ARCHITECTURAL REVIEW BOARD MEETING

PROJECT COMMENTS

PROJECT NUMBER: SP2024-046
PROJECT NAME: Site Plan for 2686 S. Goliad Street
SITE ADDRESS/LOCATIONS: 2686 S GOLIAD ST

PROJECT NUMBER: SP2024-048
PROJECT NAME: Site Plan for River Dog Retreat
SITE ADDRESS/LOCATIONS: 100 S JOHN KING BLVD, ROCKWALL, TX 75087

3 SOUTH ELEVATION
SCALE: 1/8" = 1'-0"

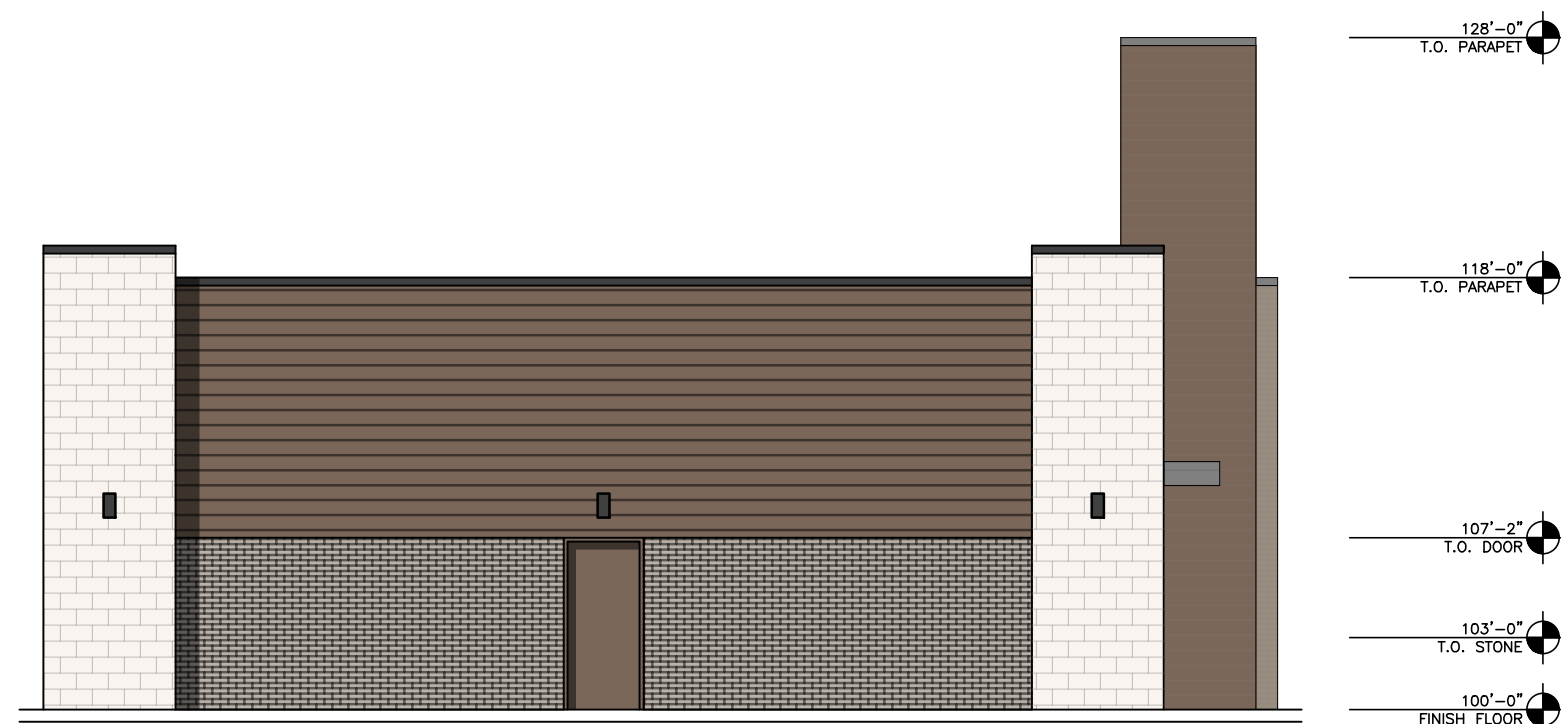
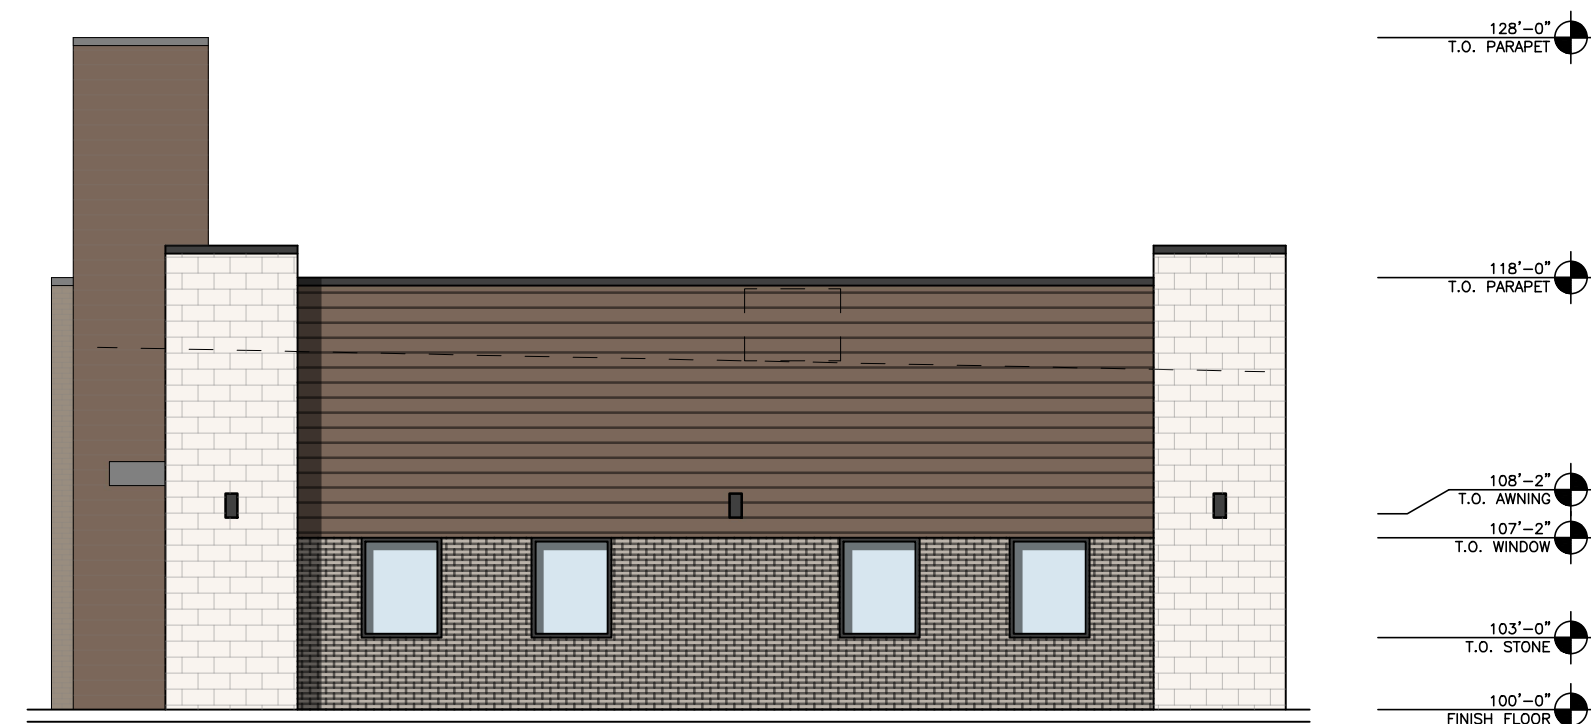
- (2) Please provide a note that the back side of the parapet must be finished in the same material as the external facing façade. In addition, all parapet systems must be enclosed. In this case, it appears that there is no parapet on the back of the building. (Subsection 06.02, of Article 05, UDC)

- (4) The proposed building does not meet the four (4) sided architecture requirements. This requires the same “materials, detailing, articulation and features” on each façade. In this case the primary articulation requirements must be met on each side, and the same architectural detail and features must be provided on each side. (Subsection 06.02, of Article 05, UDC)

9 WOOD SCREEN FENCE
SCALE: 1/2" = 1'-0"

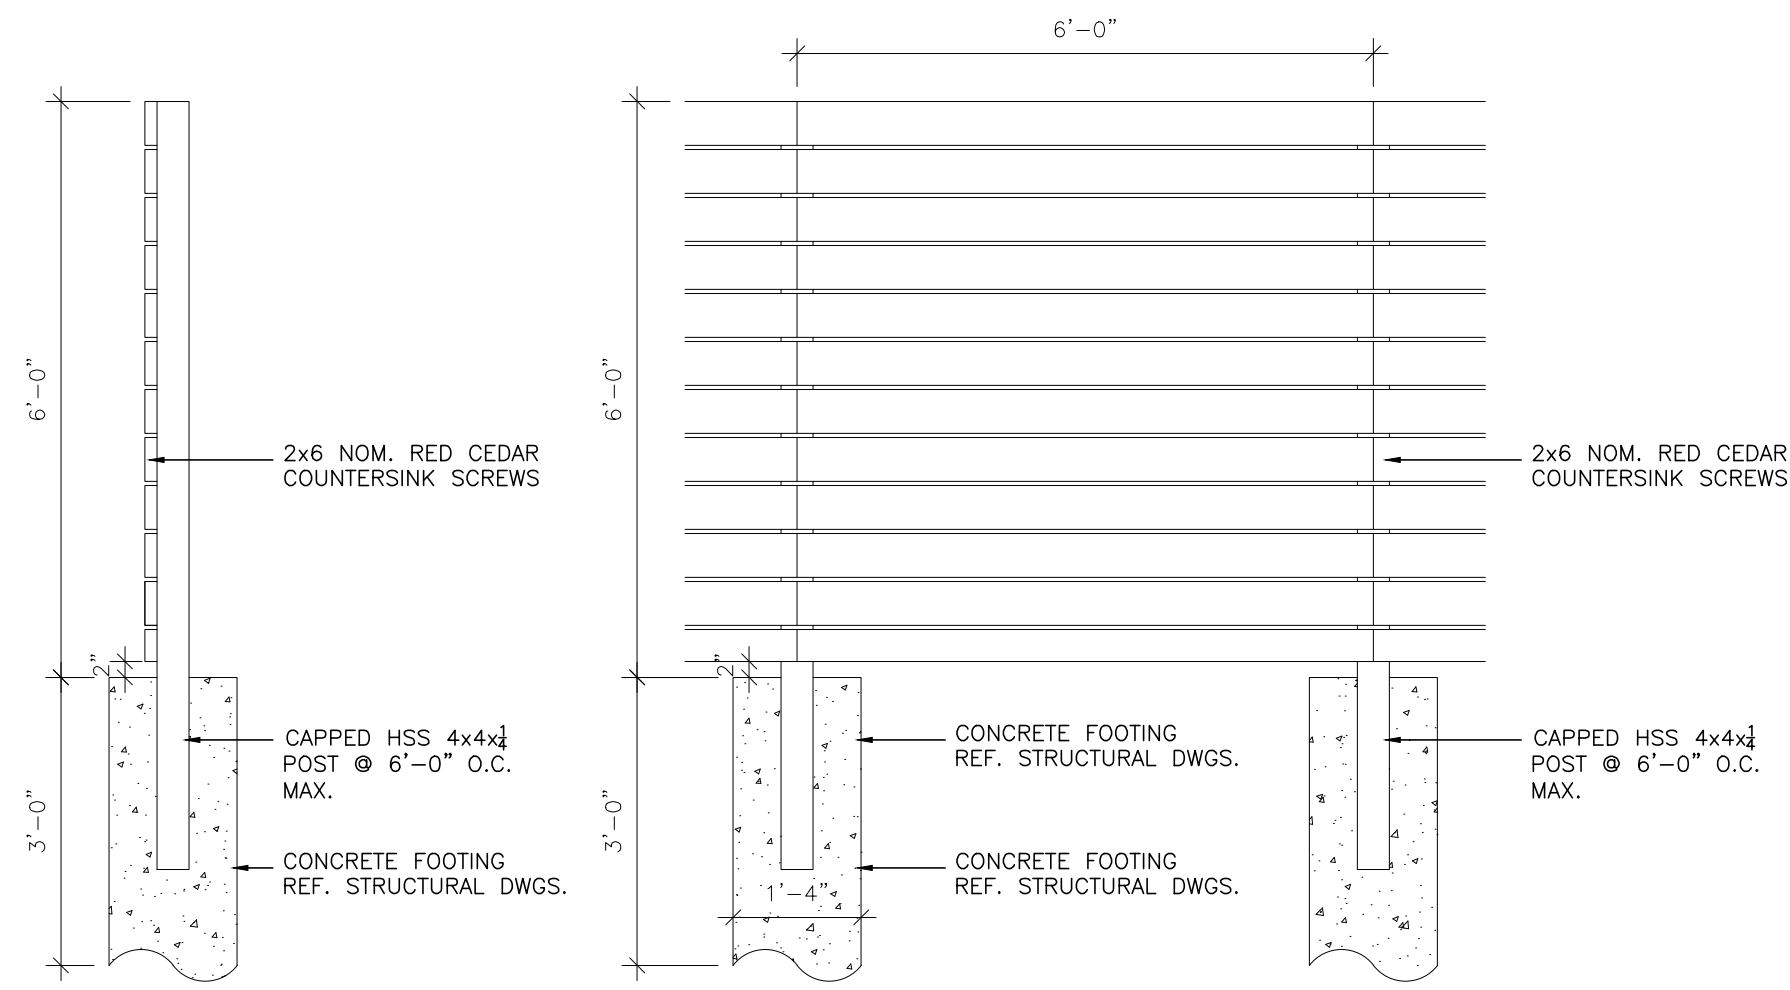
- (11) Wood is not a permitted fence material. I did not see a callout for a wood fence on the site plan, but included with the dumpster enclosure detail was a wood fence detail. (Subsection 08.02.F, of Article 08, UDC)
